PARTS & SERVICE NEWS

REF NO.	AA97049B
DATE	November 19, 1997

SUBJECT: REPOSITIONING OF DUST INDICATOR TUBE

APPLICATION: WA600-1LE Wheel Loaders Serial Number A51001 to A51043.

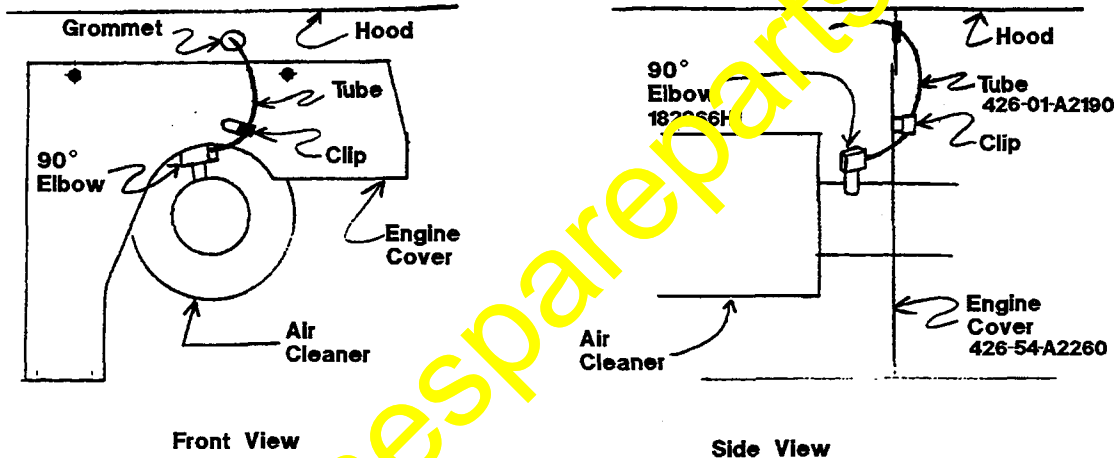
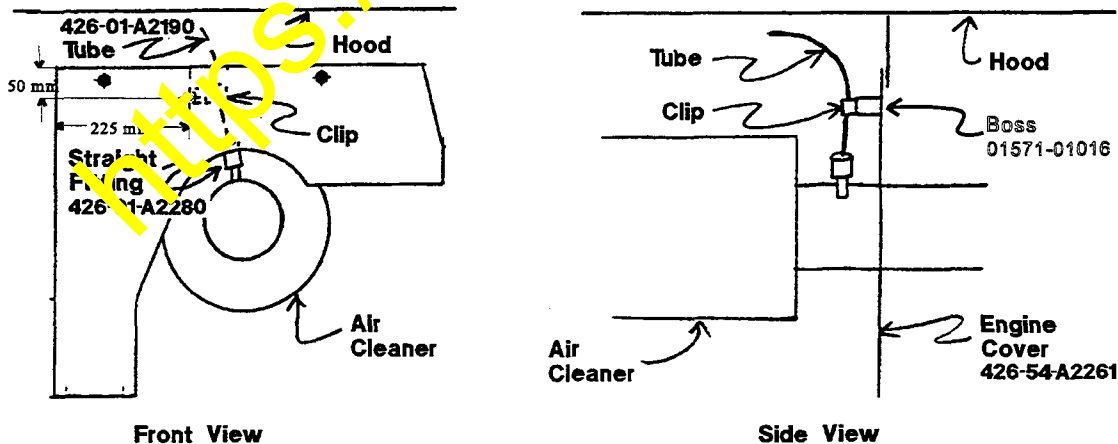
PURPOSE: To eliminate interference between dust indicator tube and engine cover plate.

The original design has the tube (1200 mm in length) running from a 90° elbow, under the engine cover, through a clip and then through a grommet in the hood top.

The improved design has the tube (1050 mm in length) running from a straight fitting up through a clip.

Note: Engine Cover P/N 426-54-A2260 can be reworked into P/N 426-54-A2661 by adding the Boss P/N 01571-01016 per the above sketch.
